UNITED STATES ENVIRONMENTAL PROTECTION AGENCY
REGION IX
75 Hawthorne Street
San Francisco, CA 94105

The U.S. Environmental Protection Agency has conducted an inspection of the Site 1 Landfill Cap at Moffett Federal Airfield. This inspection was performed by TRC, a subcontractor to TechLaw Inc., under an EPA contract. EPA performed this inspection to assess whether the remedial action is consistent with the Remedial Design. Detailed comments are attached.

INSPECTION OF THE SITE 1 LANDFILL CAP AT MOFFETT FEDERAL AIR FIELD MOUNTAIN VIEW, CALIFORNIA

ATTACHMENT 1
DEFICIENCY LOCATION MAP

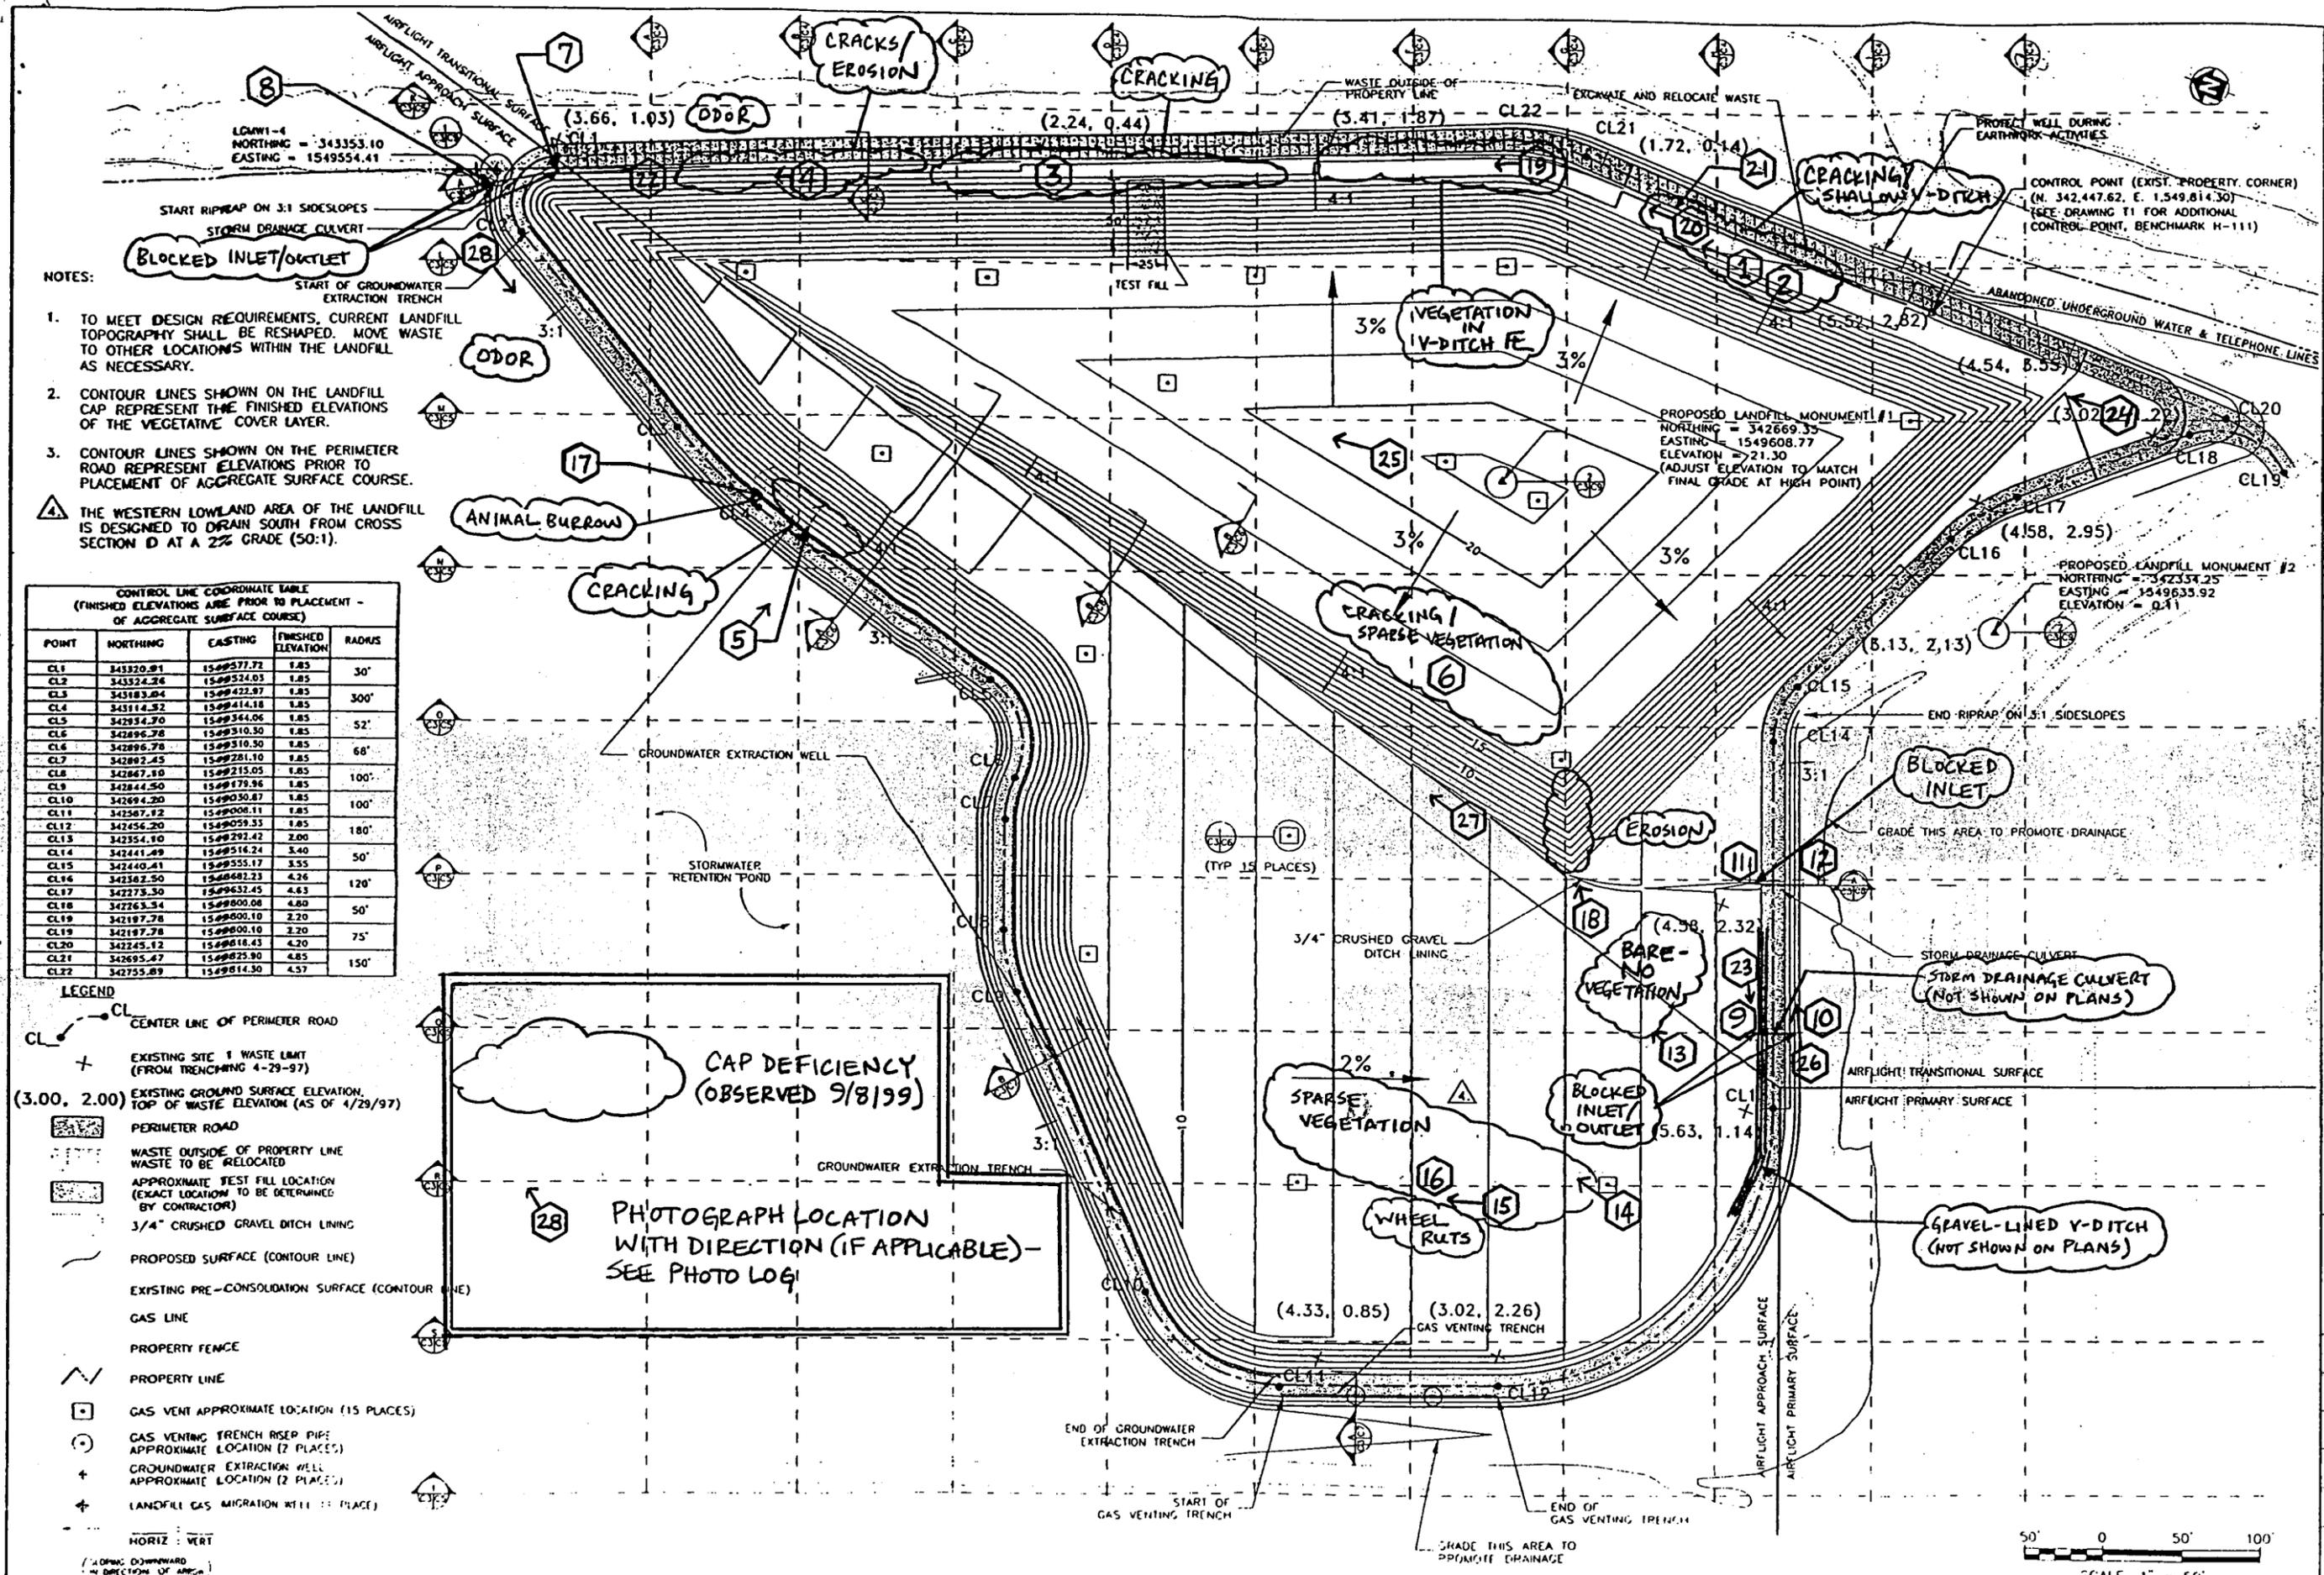
28 CAP DEFICIENCY (OBSERVED 9/8/99)

Photo 19 - Vegetation in v-ditch on NE side.

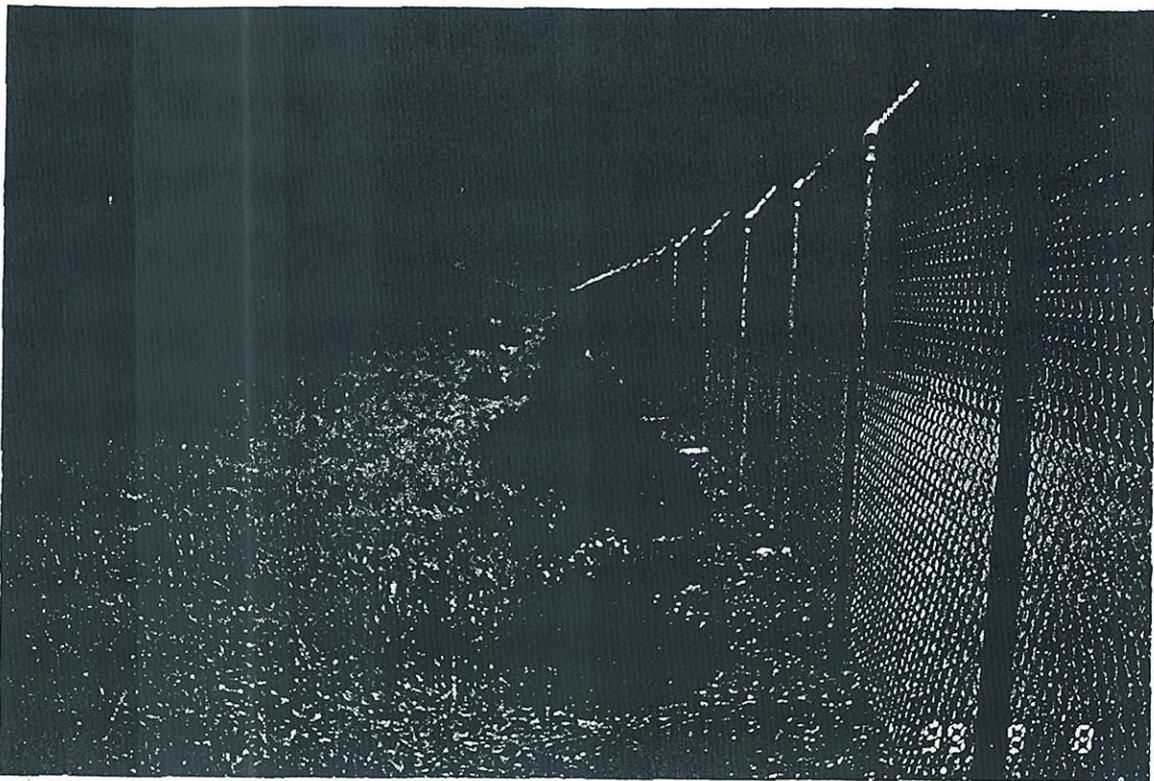
Moderate to heavy vegetation exists in the v-ditch on the northeast side of the landfill (Photo 19). This vegetation will block the surface water runoff from the landfill and, subsequently, increase the likelihood of landfill erosion.

To ensure proper surface water drainage, all v-ditches should be cleared of any vegetation which could affect flow performance prior to the rainy season.

Photo 20 - Wider/shallower (approximately 6" depth) v-ditch on SE side.

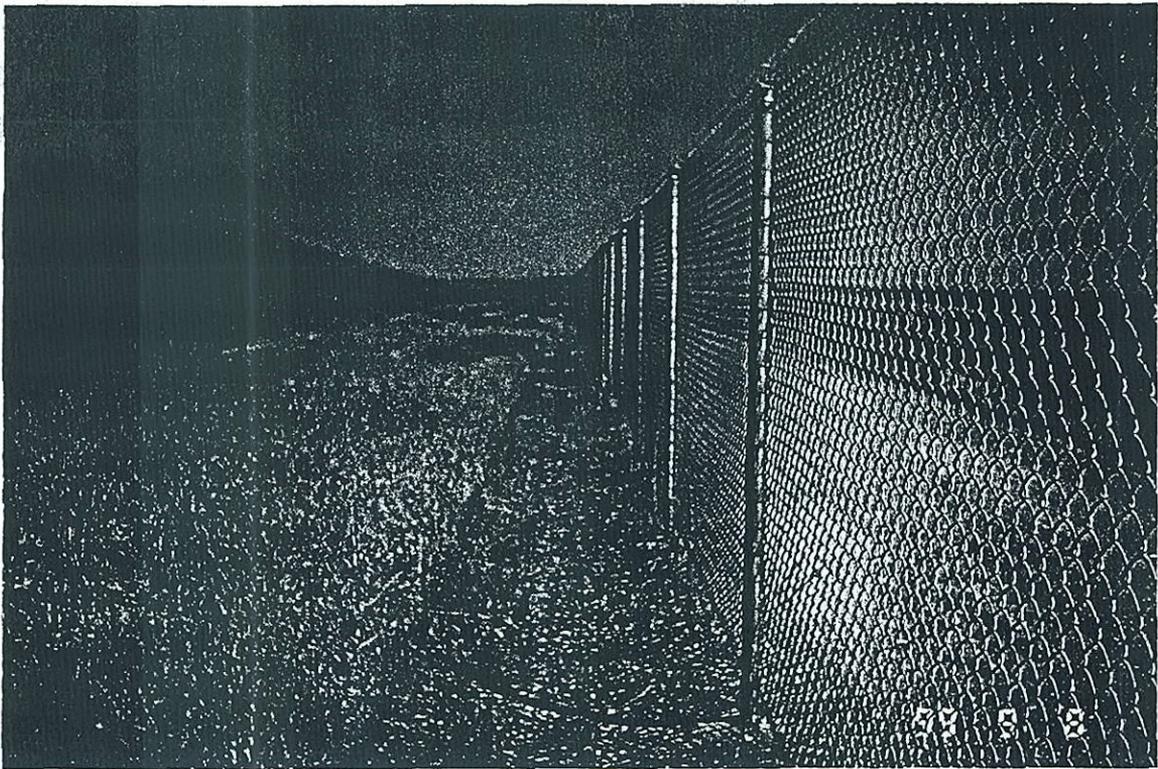
The v-ditch along the southeast side of the landfill appears to be approximately 6 inches deep, which is less than the depth (1-foot) shown on the Design Drawings (Photo 20 and 21).

Since the shallow depth of the v-ditch could adversely affect the ability of the ditch to perform as designed and remove surface water from the landfill, the depth of the ditch should be increased to 1 foot.

Photo 22 - Gravel silt trap in v-ditch on NE side (not shown on plans).

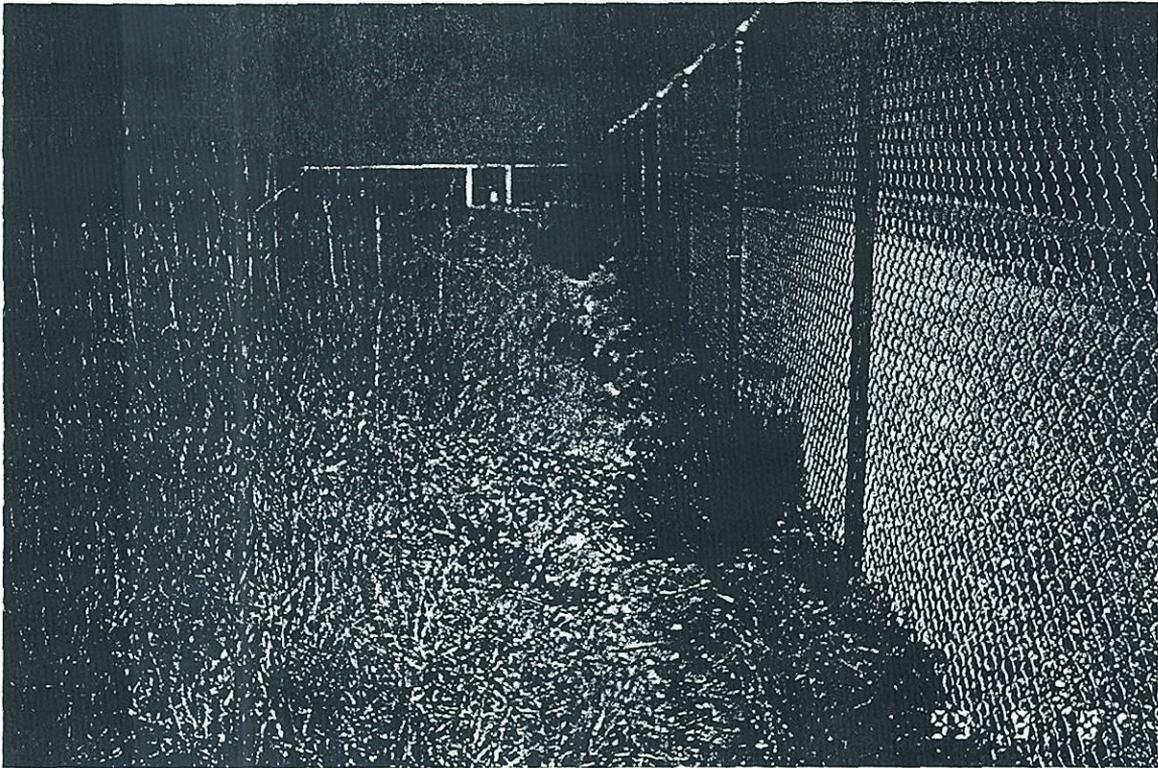
Gravel silt traps (Photo 22) and an additional gravel-lined v-ditch and culvert (Photo 23) were observed at the landfill although these components are not shown on the Design Drawings. Since the as-built drawings were not available for review, it is unclear whether these additional components are shown in the as-built drawings.

For consistency and completeness, these additional components should be shown on the as-built drawings.

Photo 23 - Gravel-lined v-ditch on SE side of lower deck (not shown on plans); flow line blocked by vegetation.

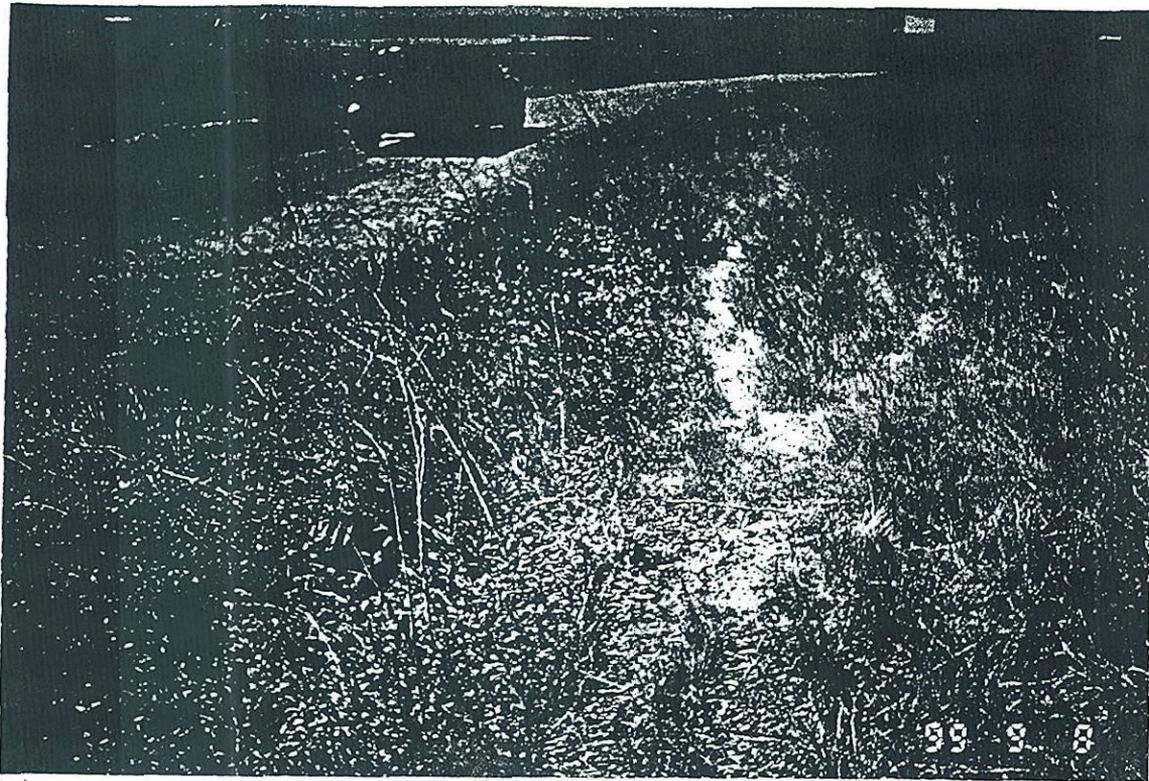
In addition, the v-ditch is moderately blocked by vegetation. To ensure proper surface water drainage, the additional v-ditch should be cleared prior to the rainy season.
